Review of Existing Licence

Division 3, Part V *Environmental Protection Act 1986*

Licence Number	L6831/1997/12
Licence Holder	Shire of Collie
File Number	DER2017/000540-1
Premises	Gibbs Road Putrescible Landfill Site Gibbs Road COLLIE WA 6225 Legal description - Lot 500 on Deposited Plan 76826
Date of Report	5 July 2021
Status of Report	Final

Figure 2: Approximate layout of premises infrastructure and operational areas.

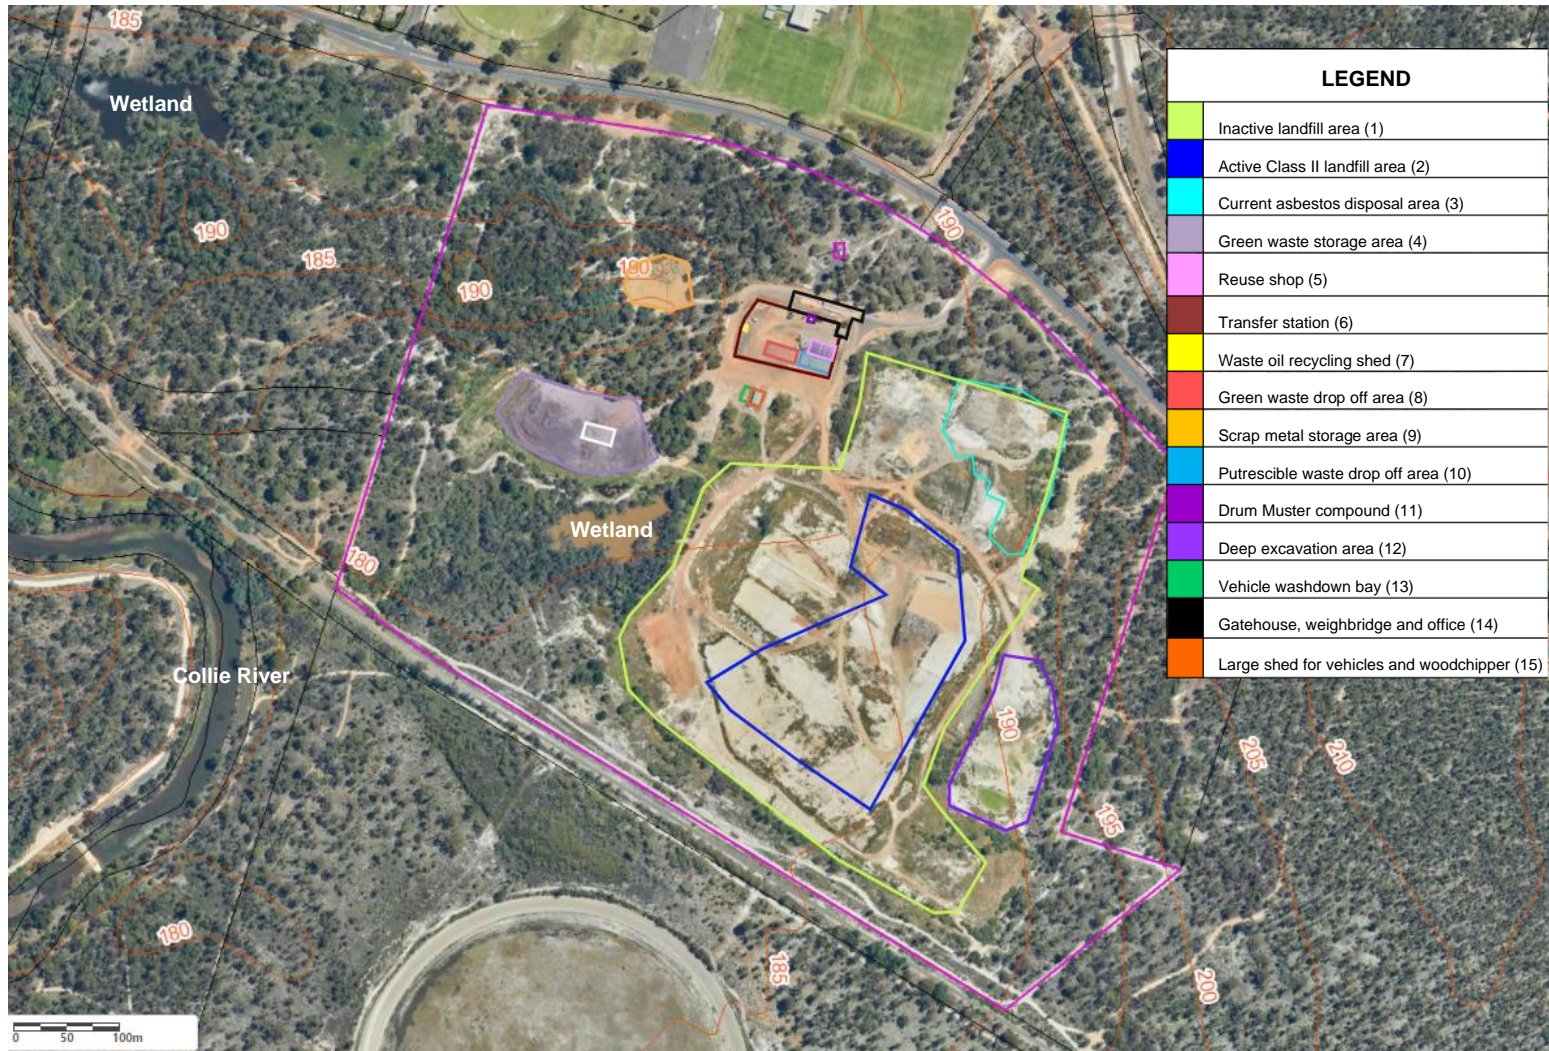
Condition	Summary of Licence Holder comment	DWER response
<p>4 – Infrastructure and equipment</p> <p>Figure 2 – premises layout and infrastructure</p>	<p>Updated map of groundwater monitoring locations provided.</p>	<p>The Monitoring Locations Map (Figure 3 in the Revised Licence) was updated to show the groundwater monitoring locations as depicted in the map provided by the Licence Holder.</p>
<p>5 – Waste processing</p>	<p>Uncontaminated Fill and Inert Waste Type 2 – updated map shows updated area</p>	<p>The draft Revised Licence specified that tyres (Inert Waste Type 2) are stored on hardstand within the transfer station. The map provided by the Licence Holder shows the part of the transfer station where tyres are stored, however the Delegated Officer considers that this specific location is not required to be defined in the Revised Licence.</p> <p>The draft Revised Licence does not specify any limitations on where uncontaminated fill is stored or reused on the premises.</p>

Figure 2 – Operations and Infrastructure Map	<p>The Licence Holder provided an updated map showing the operations and infrastructure layout, including an updated Special Waste Type 1 burial area.</p>	<p>Figure 2 in the Revised Licence was updated to better reflect the Licence Holder's current operational areas. The following changes were made:</p> <ul style="list-style-type: none"> • Slight expansion of the green waste storage area to the west of the area shown in the draft Revised Licence. • Expansion of the Special Waste Type 1 disposal area to the east and south of the area shown in the draft Revised Licence. • The waste oil recycling shed was moved from the centre of the transfer station to the western side of the transfer station. • The newly constructed reuse shop was added. <p>The Delegated Officer considers that the above changes do not</p>

Figure 4: Temporary leachate bund on 12 August 2010 (a) and 10 February 2020 (b)

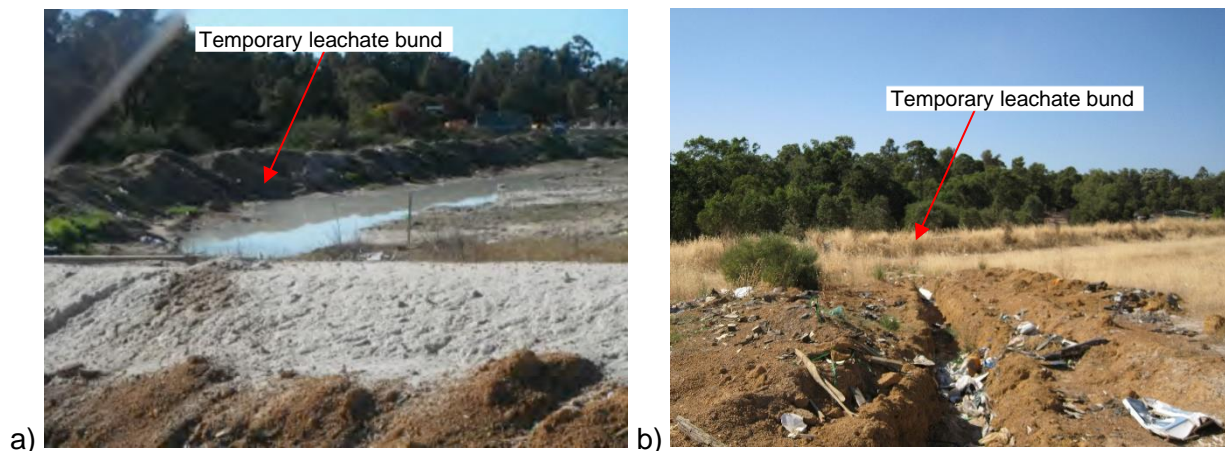
Based on observations made during site inspections, the Licence Holder has not demolished the temporary leachate bund or installed the permanent cap proposed for this area in the LPMP (Figure 4). From observations it appears that the Licence Holder has not implemented most aspects of the permanent leachate management system.

The temporary bund to the west of the landfill was observed during the most recent inspection

in February 2020 (Figure 4). The Licence Holder indicated that it was no longer needed as their changed landfilling practices, such as the use of intermediate cover, had prevented leachate discharge at the downslope edge of the landfill.

Figure 16: Groundwater monitoring bore network

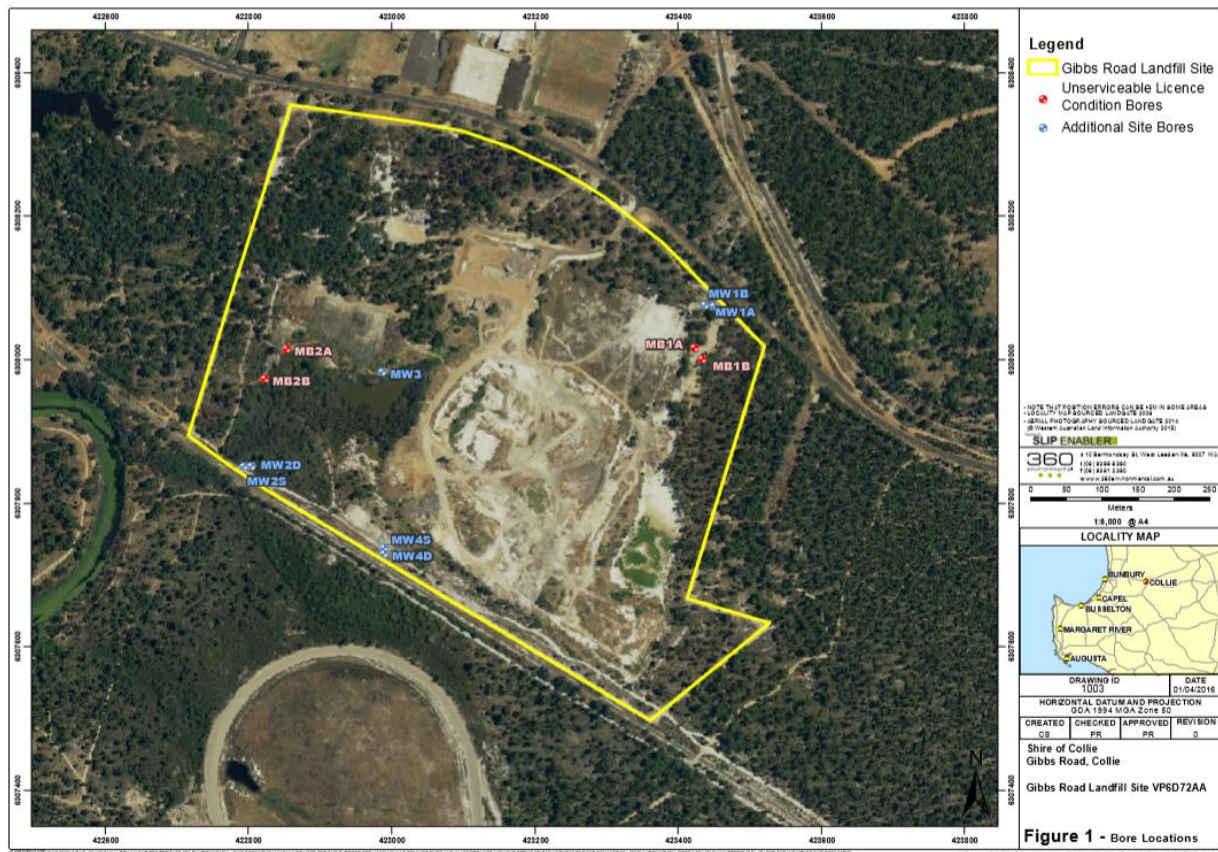
A total of eleven monitoring wells are located on the Premises (Figure 16). Little is known about the construction and installation of the monitoring wells, with the exception of three groundwater monitoring wells installed by Stass Environmental in 2010 (bore construction reports provided in Stass, 2010).

The original groundwater monitoring wells MB1 (A and B) and MB2 (A and B) are located to the east and west of the landfill respectively (marked in red in Figure 16). The A and B designate shallow and deep, although the total depth of the wells is unknown. The wells are not regularly sampled, and it is unknown whether they have been decommissioned, they were labelled as unserviceable in a 2016 groundwater monitoring program review (360 Environmental, 2016).
